**KNOXVILLE HISTORIC ZONING COMMISSION
STAFF REPORT - CERTIFICATE OF APPROPRIATENESS APPLICATION**

PROPERTY LOCATION: 110 13th St. /
Parcel ID 94 L M 012

FILE NO.: 11-C-19-HZ

MEETING DATE: 11/21/2019
APPLICANT: William Wilson (Contractor)
LEVEL OF WORK: Level III. Construction of new primary building

Left Side Elevation

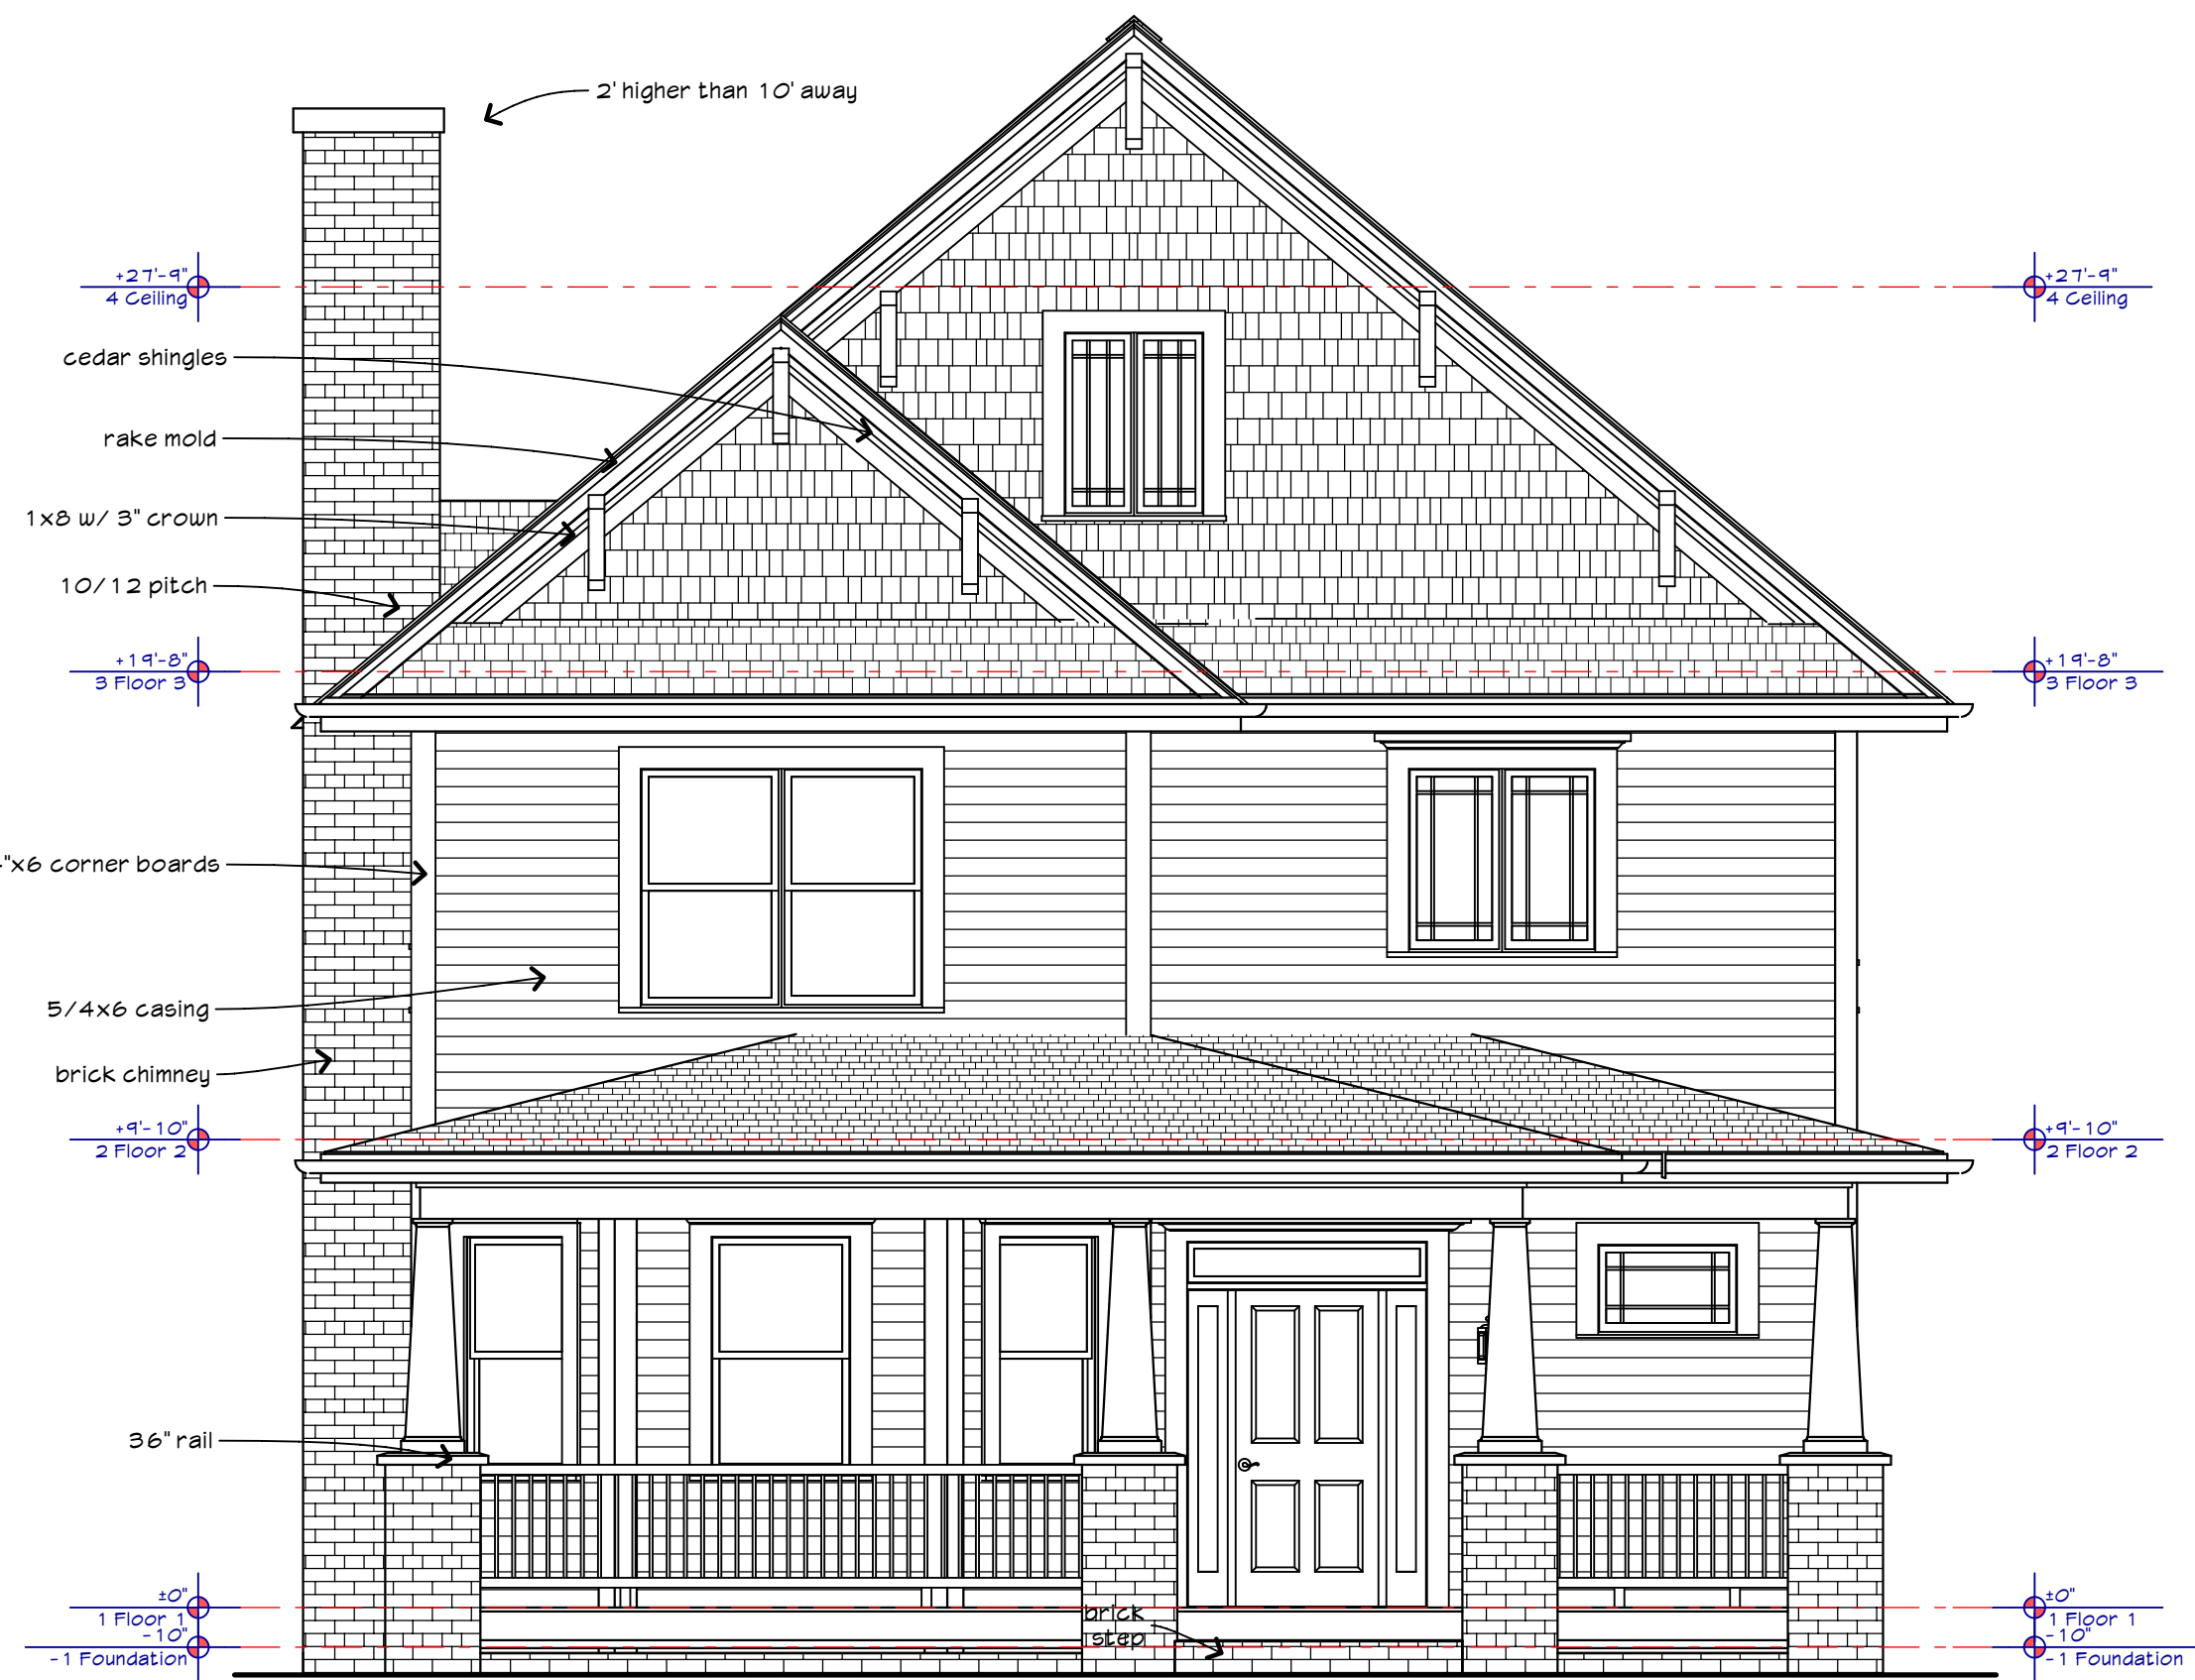
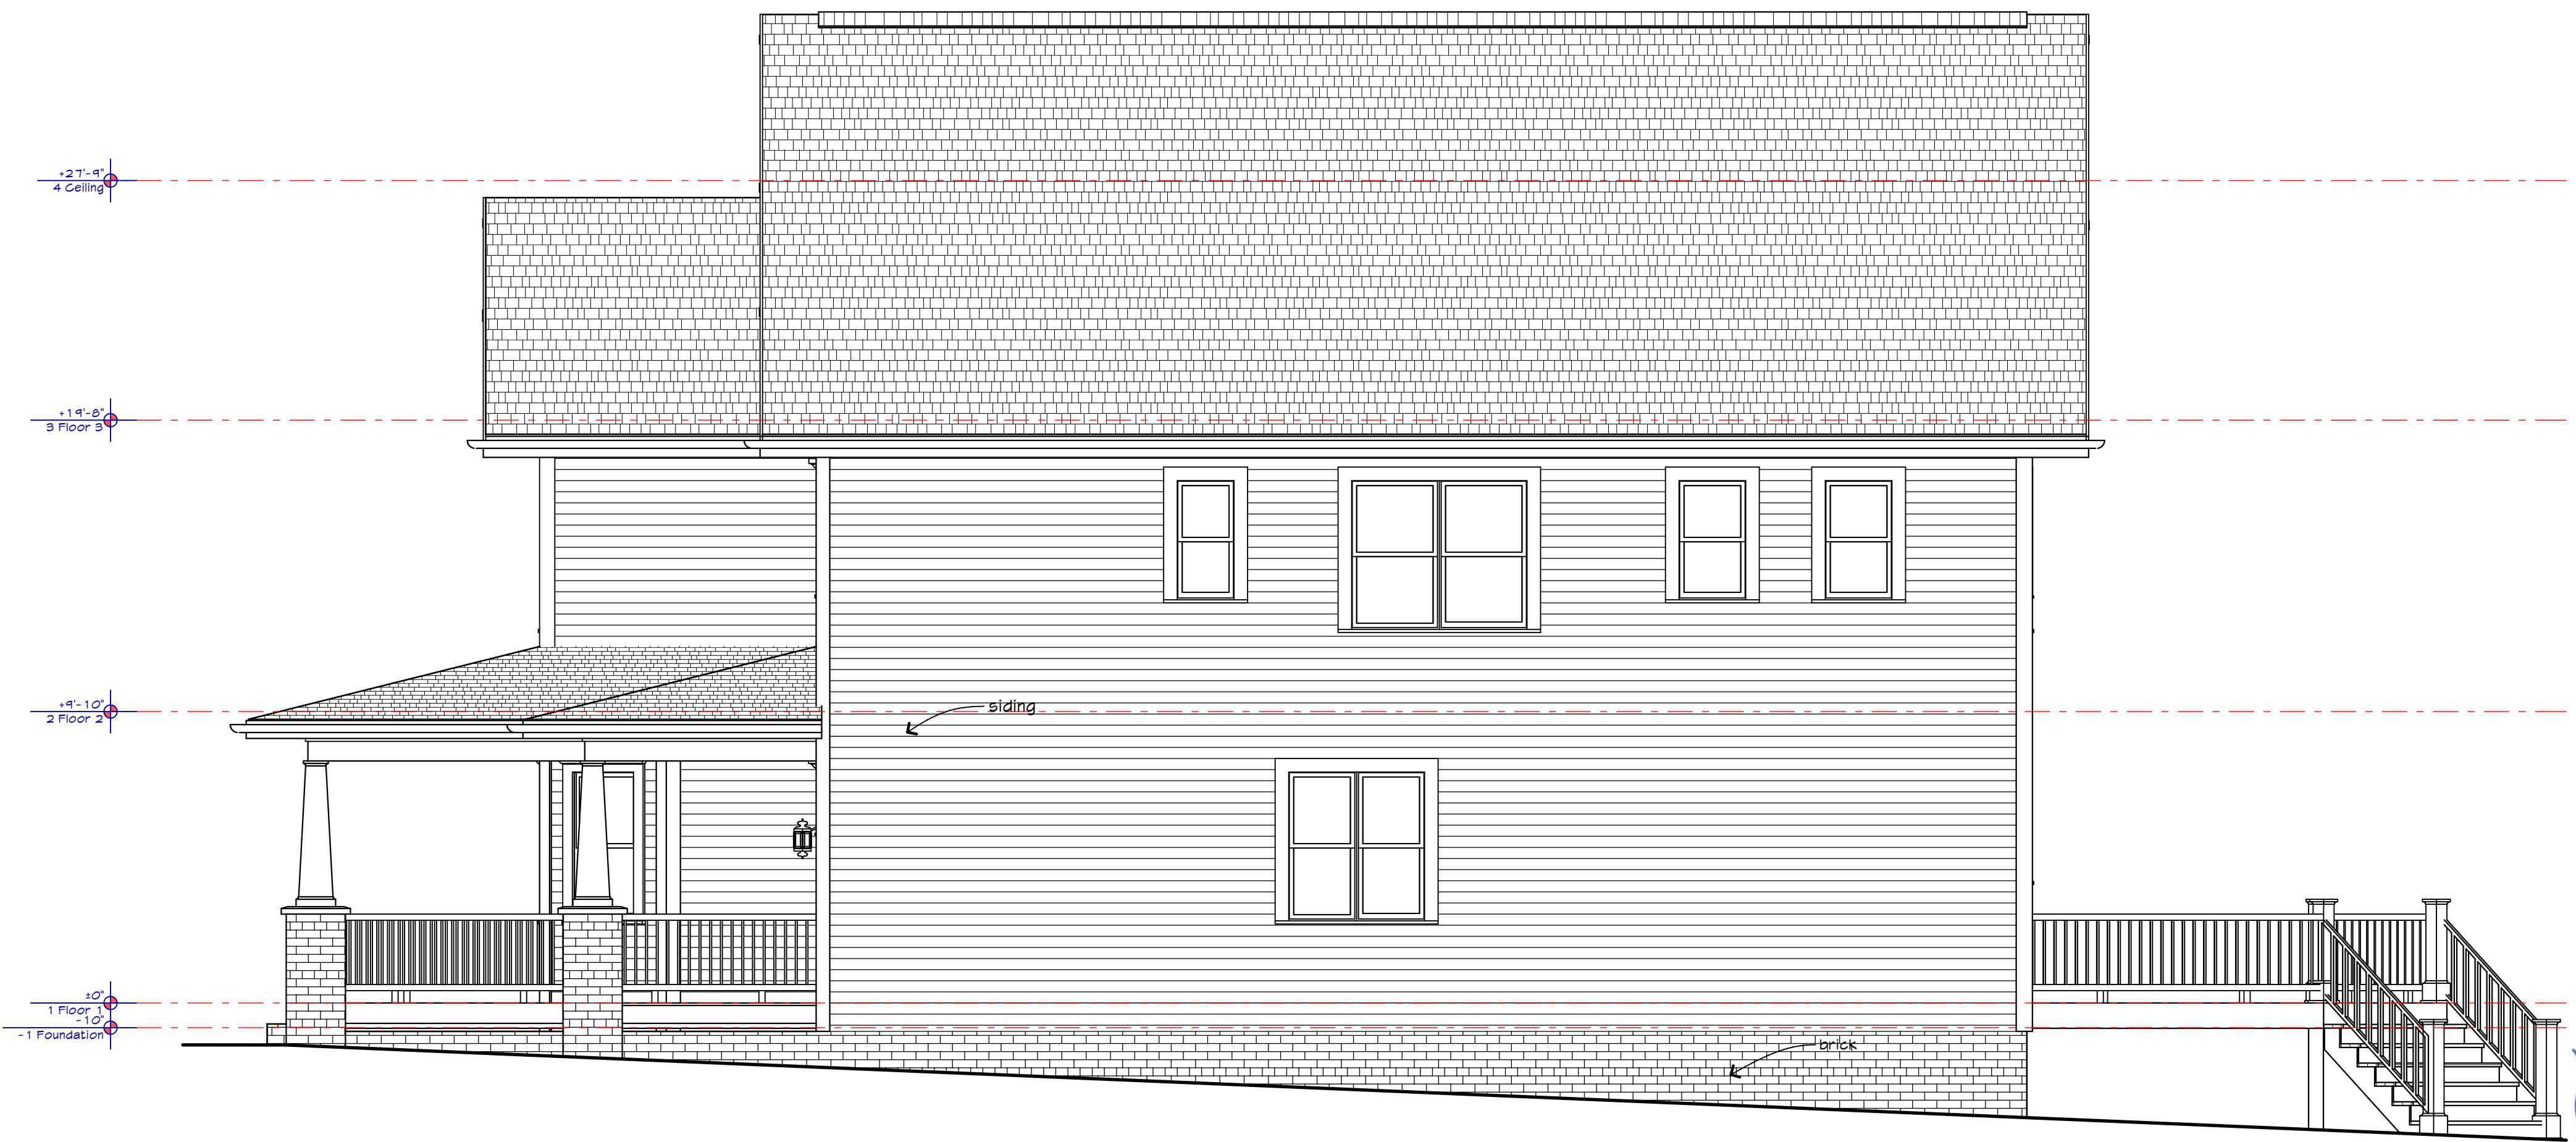
8. On the façade (south) elevation, the proportions and placement of windows reflects the historic neighborhood context. On the highly visible west elevation fronting 13th Street, first and second-story window placement does not reflect historic window symmetry. Second-story windows should be aligned with the first-story windows. The rear (north) elevation features a multi-light accent window on the second story. Guidelines note that accent windows are appropriate with new construction; however, the placement is not reflective of historic window symmetry and should be centered over the first-story windows. On the east elevation, the proportions of the second-story windows exceed those of the first story.

Staff recommends approval of the work as proposed, with the following conditions: 1) east, west, and rear elevation window placement be re-designed to better reflect historic patterns of window symmetry, with approval of new design by staff; 2) one native shade tree to be planted in the front and rear yards; and 3) the existing retaining wall be reconstructed in brick or stone to maintain the block's existing topography.
